RESOLUTION R-4731

A RESOLUTION OF THE CITY COUNCIL OF THE CITY OF KIRKLAND ADOPTING FINDINGS AND CONCLUSIONS GRANTING DESIGN REVIEW APPROVAL OF AN ALTERNATIVE DESIGN FOR THE BANK OF AMERICA/MERRILL GARDENS MIXED USE PROJECT AT 101 KIRKLAND AVENUE. (FILE NO.: DRC 07-0006; APPEAL CASE NO.: APL08-0001)

5 STORY ALTERNATIVE - 10.31.08
ER 408 Settlement Purposes Only/Do NOT Distribute

5 Story Alternative 10.31.08

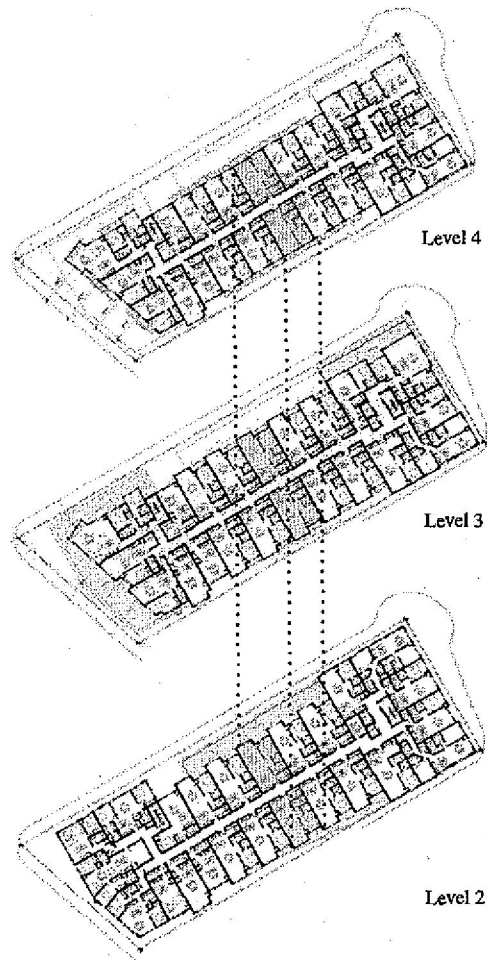
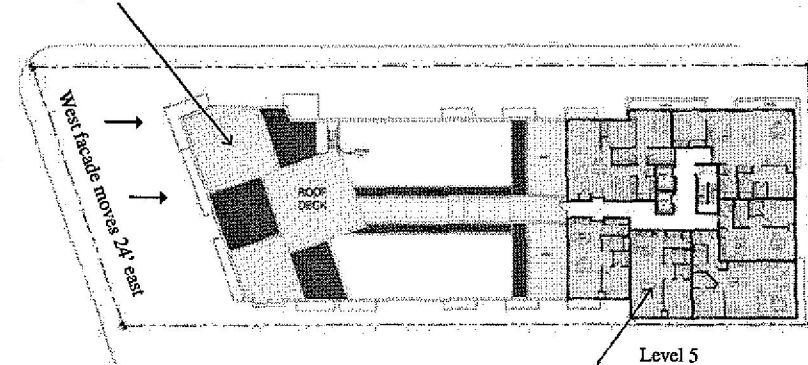
remove 6 units from the center
of the 4 story building

Re-establish roof top deck

relocate the 6 units to a small fifth level on the east building

The 5 story alternative is presented as a way of maintaining the economics of the building, yet providing significant pedestrian enhancements. By simply reallocating 6 units in the body of the 4 story building to a very small 5th floor, most of the west facade can be moved east by 24', the width of these units. This allows for a plaza 25% larger than what was approved by the DRB, restores an 35% larger cafe space onto Lake Street, and creates a lasting public amenity on one of the main corners of downtown Kirkland.

Plaza Square Footage

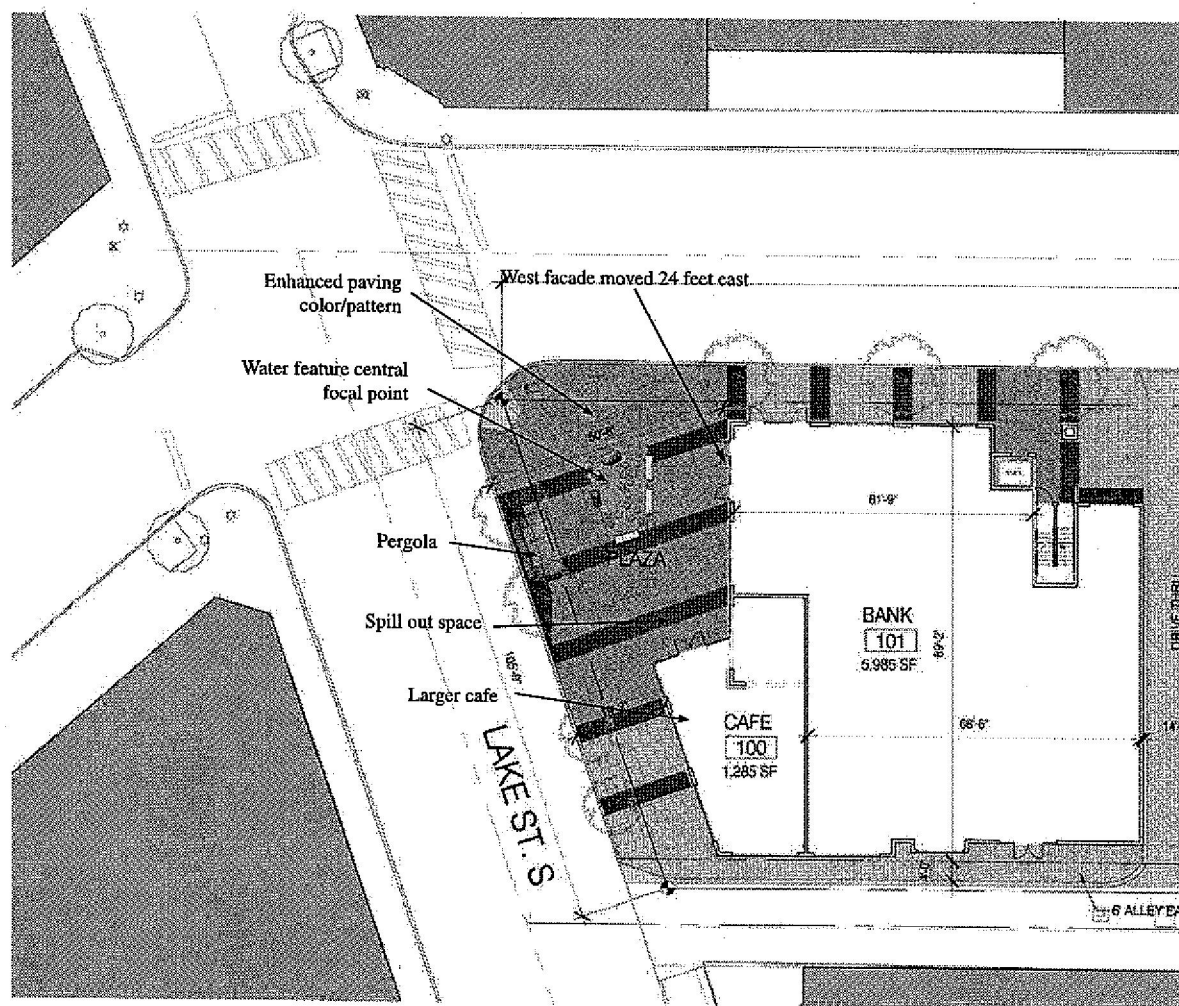
With the 5 story alternative the plaza is 25% larger than the original design and 50% larger than any of the settlement designs presented to date. The water feature is again the central feature and the cafe has a significant presence on the plaza with spill out space for tables and chairs. The sidewalk in front of the cafe is over 19' wide and the plaza opens up to nearly 50' on the north end. The pergola and enhanced paving remain.

3.12 Along Lake Street South, the first and second stories of the building are proposed to be located from 19 to 51 feet from the curb. This will result in a public plaza of 2,800 square feet, nearly 800 feet larger than that approved by the Design Review Board. *Alternative Design plans at A.2 and B.1.* The public plaza will be 50 feet wide at its widest point, and include a 19-foot-wide sidewalk, an interactive water feature as a central focal point, a pergola over an east-facing bench, and enhanced paving with colored concrete banding. The public plaza is proposed for the corner of Kirkland Avenue and Lake Street South, one of the most prominent corners in the CBD.

Enlarged Plaza Features

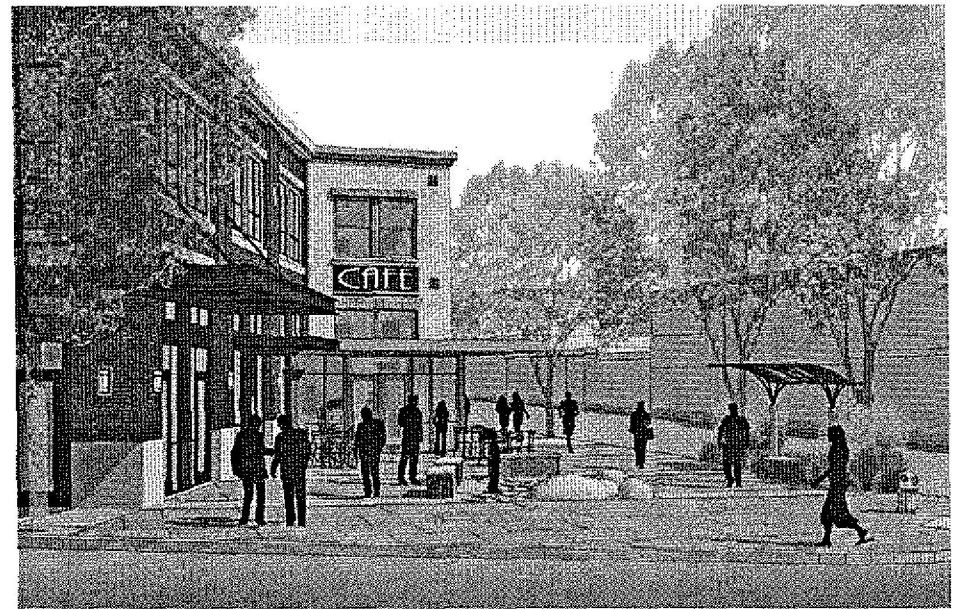
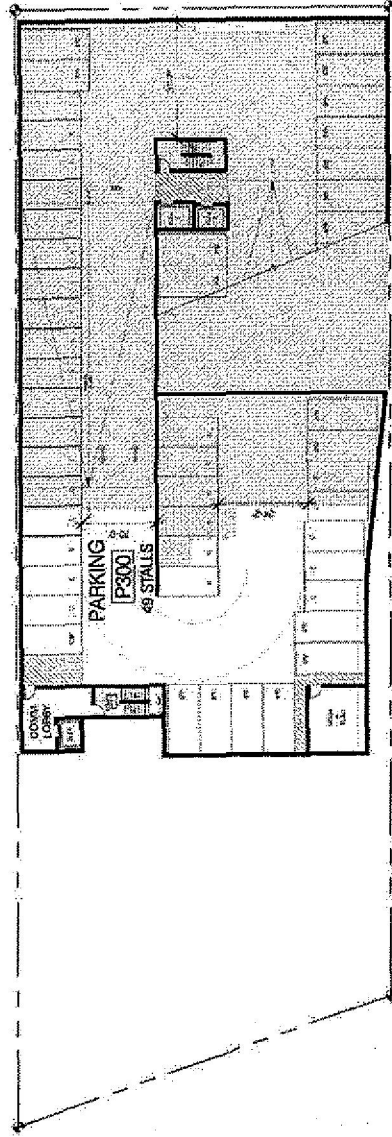
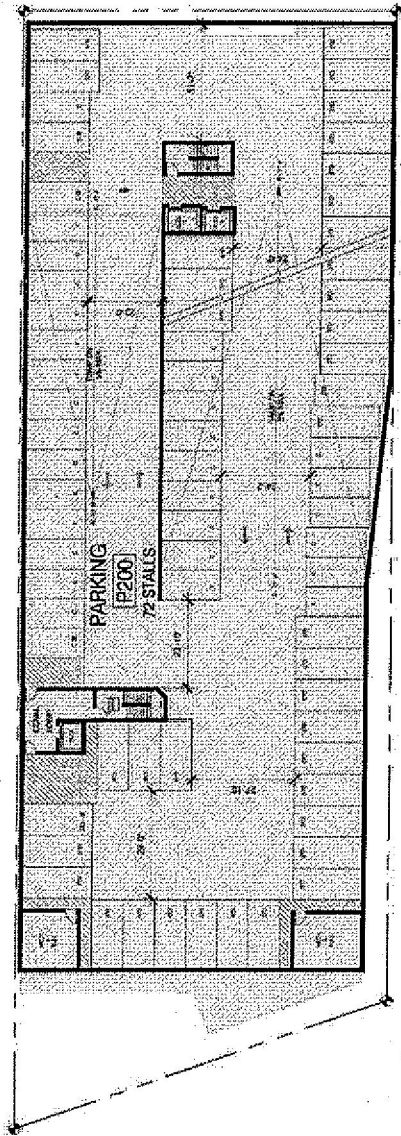
- Moved west facade east 24 feet
- 19' sidewalk in front of cafe
- Plaza 50' widest point
- Interactive water feature reinstated as central focal point
- Cafe has large presence on the plaza with spill out space for tables and chairs
- Pergola over east facing bench
- Enhanced paving with concrete banding and coloring in plaza area
- Roof deck reinstated providing activity at multiple levels along Lake St.

Aerial View of 5 story alternative

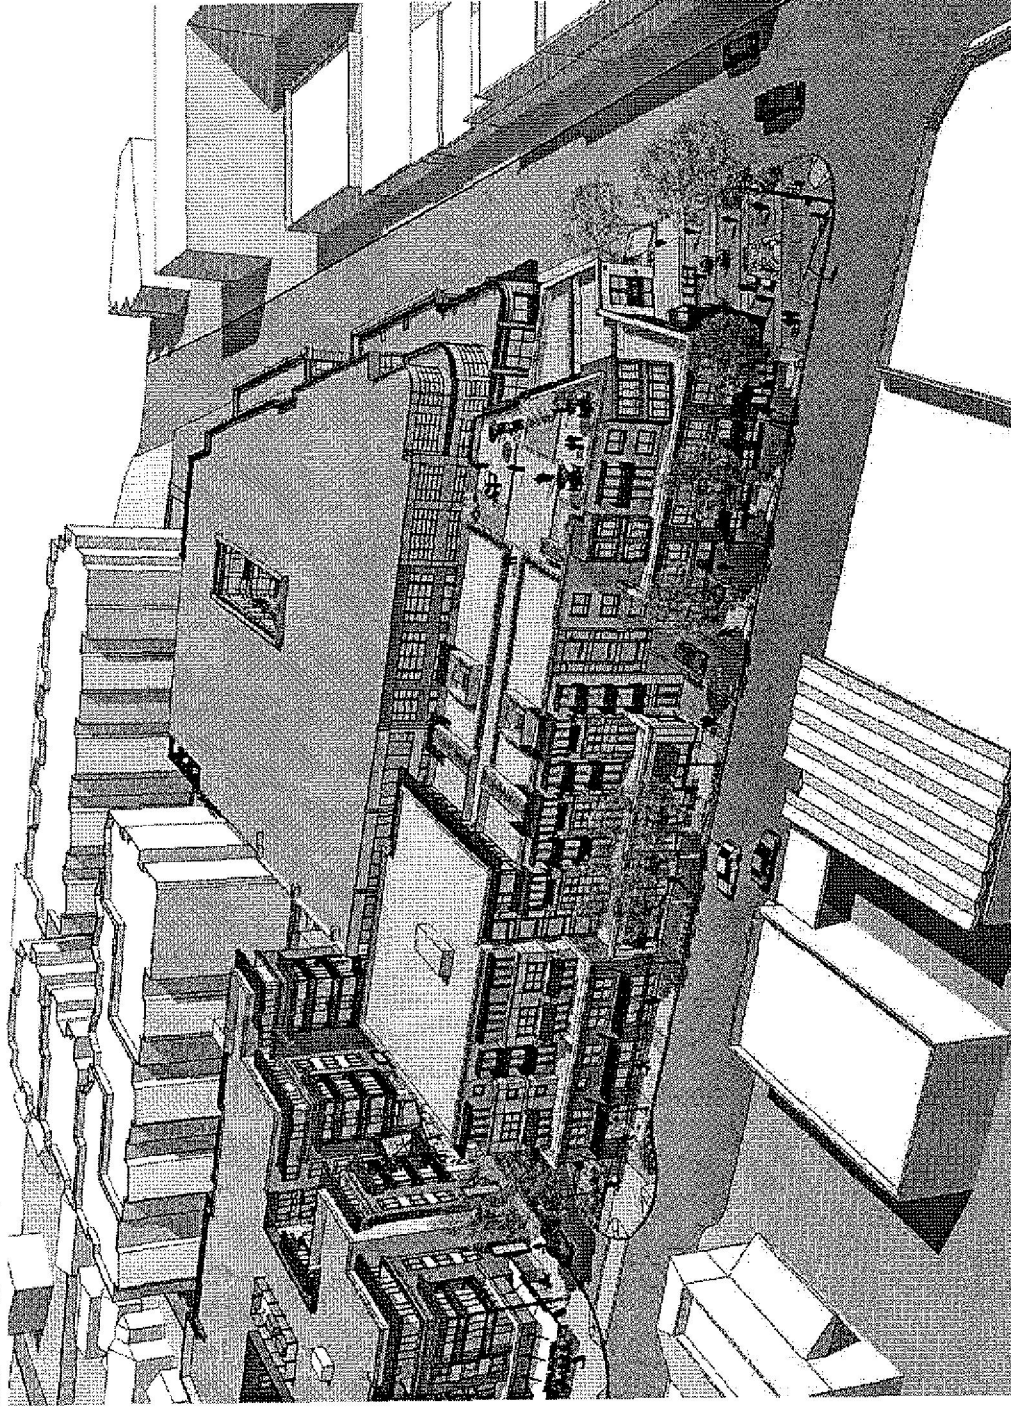
3.19 The stories above the second story of the project are set back significantly from the street and south of Kirkland Avenue the building form is stepped back at the third, fourth, and fifth stories to mitigate building mass. *Alternative Design Plans at page E.1.*

3.20 The proposed Project building form steps up from the north and west with the tallest portion at the easternmost part of the structure, and when considered against other existing and approved structures on adjacent and nearby parcels, the building forms step up from the north and west with the tallest portions located at the base of the hillside to help moderate the mass of large buildings on top of the bluff. *Alternative Design Plans at page E.1.*
